Access Compliance Report

Public Rights-of-Way

| Intersection ID: 47159 | Main Street: TODDVILLE_RD | Cross Street: SUMMEROUR_PL | Location: | N |
| ADA ID: A65A50F49702 | Ramp Type: Perp | Initial Pass/Fail: Fail | Overall Compliance: No | Severity Score: 22.5 |

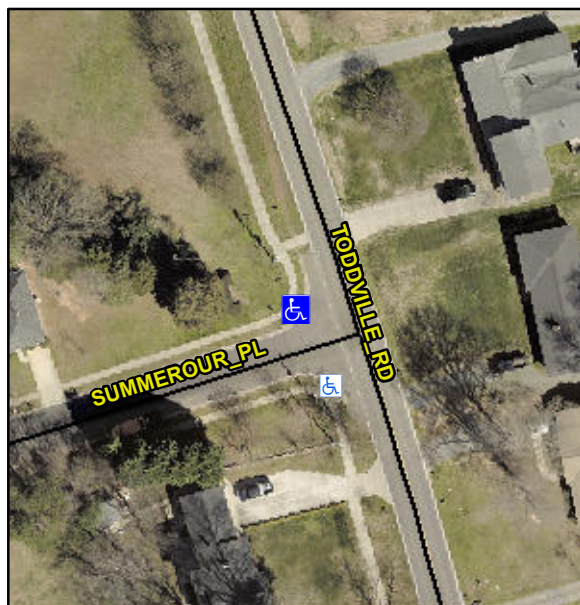
Not Found, R304.5.1, R304.2.2, R304.5.3

| Compliance | Description | Data | Compliance | Description | Data |
|------------|-----------------------|------|------------|-----------------------------|------|
| N/A | Ramp Length (in) | 53.0 | No | Ramp Slope (%) | 11.7 |
| No | Ramp Width (in) | 41.5 | No | Ramp XSlope (%) | 2.3 |

Remove & Replace Entire Ramp.
